RE: SPECIALIST TERRESTRIAL ECOLOGY OPINION – BOTANICAL ASSESSMENT REVIEW AND OPINION FOR THE CLANWILLIAM DAM ENVIRONMENTAL AUTHORISATION AND ENVIRONMENTAL MANAGEMENT PROGRAMME AMENDMENT

The Biodiversity Company was commissioned to provide a review and independent terrestrial ecological expertise on the Clanwilliam Dam Raising Study Botanical Report compiled by Dr C. Boucher in March of 2006 for the Clanwilliam Dam Raising project which was authorised in 2009. This letter serves to assist in the proposed Environmental Authorisation amendment process by providing specialist input and additional recommendations and mitigation measures that should be included in the amended EMPr.

Figure 1 Map illustrating the estimated area that was assessed in the Botanical Assessment (Boucher, 2006)

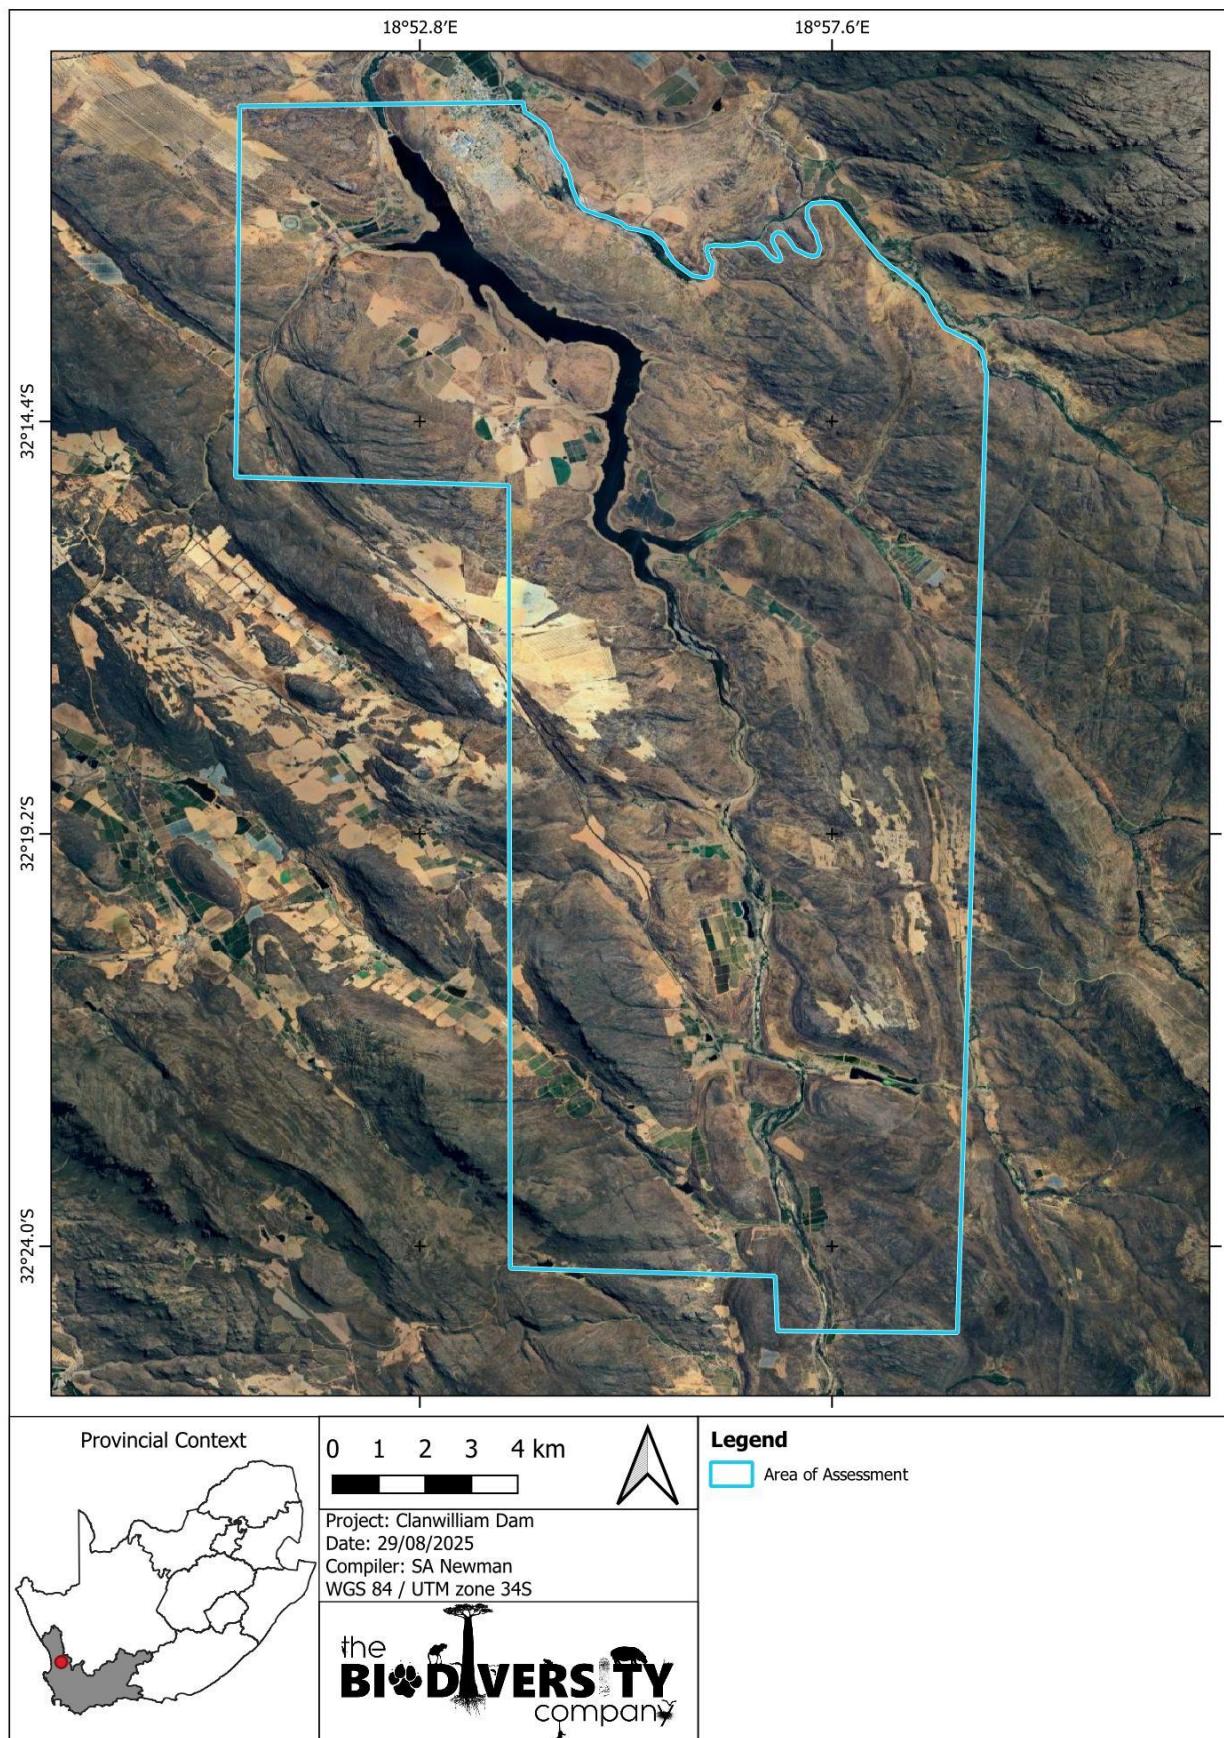
The boundary of the existing Botanical Assessment (Boucher, 2006) was not supplied clearly in the report or Record of Decision (RoD), but a rough estimation of the Area of Assessment covered by the Botanical Assessment can be seen presented in *Figure 1*. It should be noted that the original report focused specially on the 120 m Full Supply Level (FSL) boundary and road realignment areas.

In conclusion, it should be noted that the vegetation communities assessed in the original Botanical Assessment (Boucher, 2006) covered an area much larger than that of the area authorised (*Figure 1*). However, Boucher specifically focused their assessment on the 120 m full supply level area and the areas to be impacted by the N7 road realignment as these were the main areas expected to be impacted by the project activities.

Figure 2 Map depicting the recommended Project Area of Influence (PAOI) and Walkdown Area in relation to the New FSL, New HFL and project infrastructure

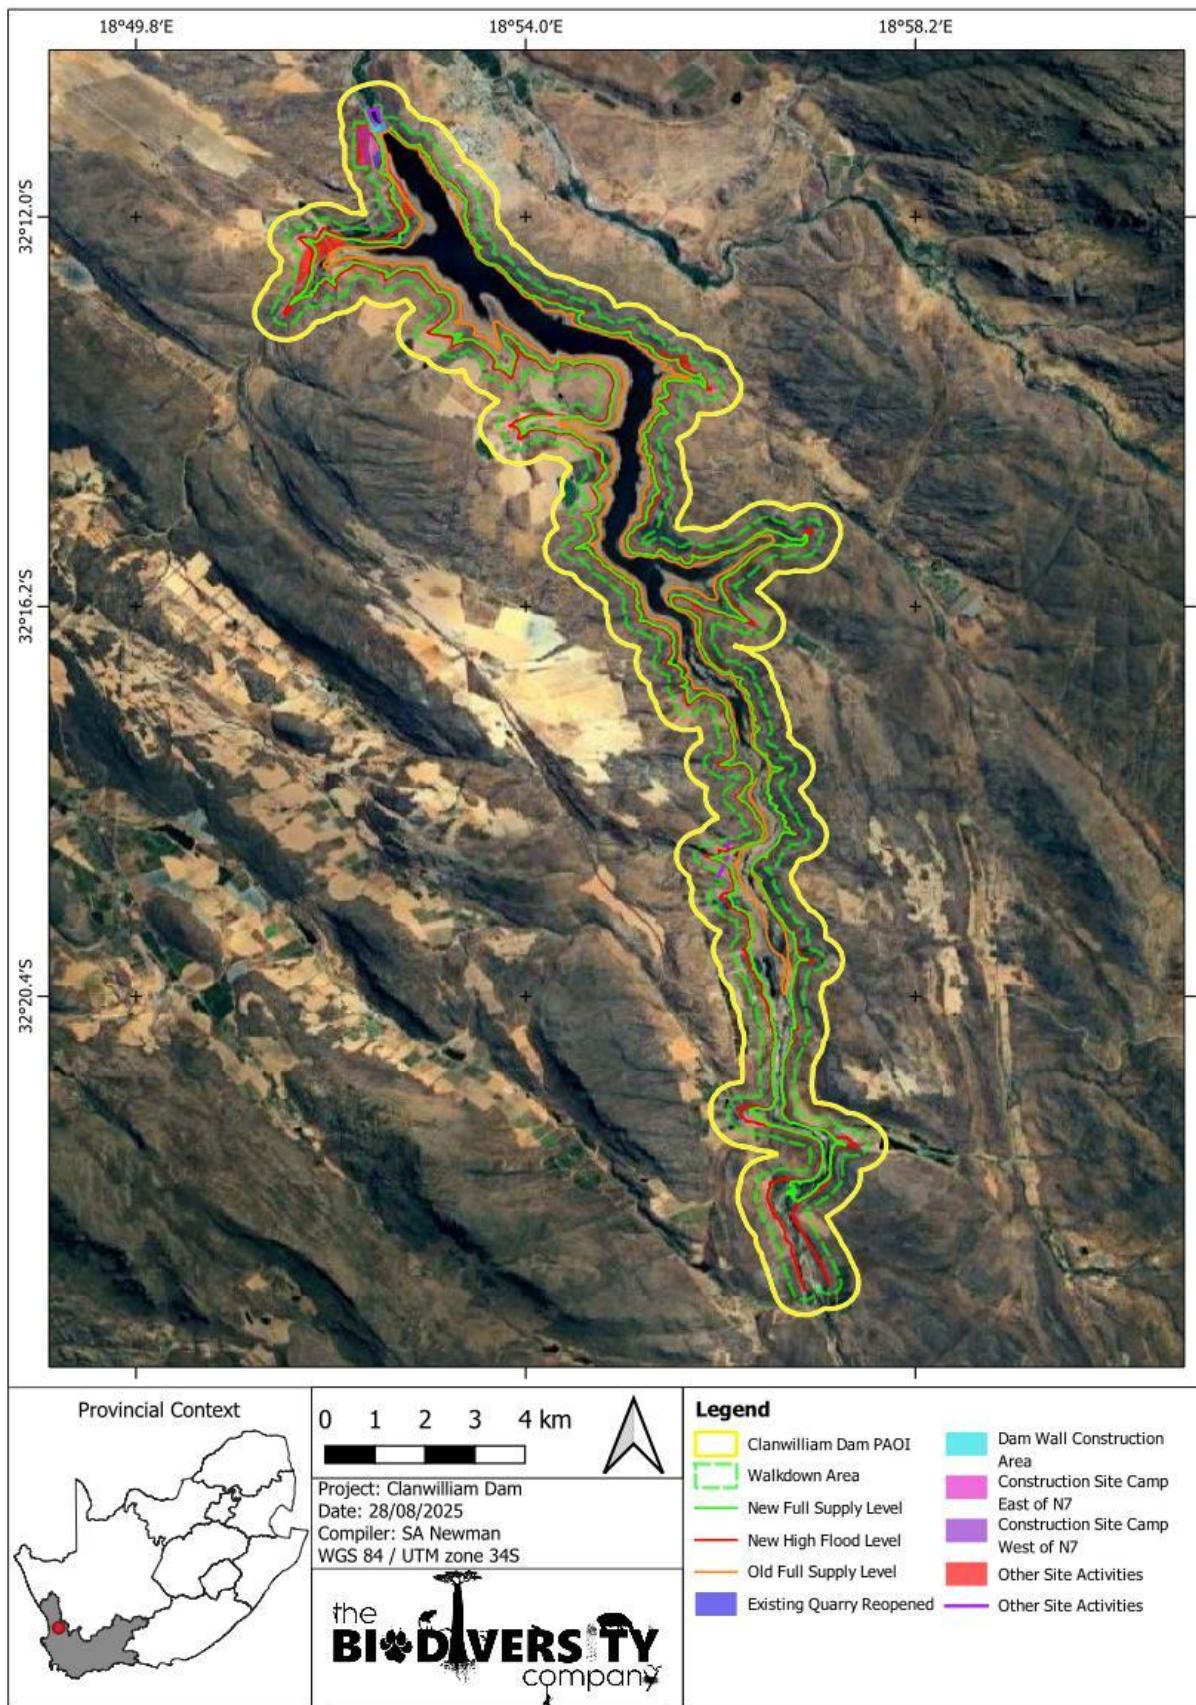
It is the specialist opinion that the following Project Area of Influence (PAOI) should be considered to appropriately mitigate the impacts of the project (*Figure 2*):

- A 500 m buffer has been applied to the New FSL and the New High Flood Level (HFL) to accommodate the area of impact expected for the surrounding vegetation communities; and
- A 200 m buffer has been applied to all site activity infrastructure, apart from the weir which also received a 500 m buffer, to accommodate the area of impact expected for the site activities.

In addition to the PAOI, a plant species of conservation concern (SCC) and protected species walkdown area (to be referred to as the Walkdown Area for the purposes of this letter) has been created and incorporates the following (*Figure 2*):

- A 200 m buffer has been applied to the New FSL and New High Flood Level (HFL); and
- A 50 m buffer has been applied to all site activity infrastructure.

It is the opinion of the specialist herein that the area that will likely be impacted by the project activities will fall within the 500 m buffer indicated in *Figure 2*. Therefore, mitigation measures will need to be applied within this buffer zone. In addition, due to the ~16 year time lapse since the authorisation, an SCC and protected species plant walkdown must be conducted for the defined Walkdown Area indicated in *Figure 2* prior to dam inundation.
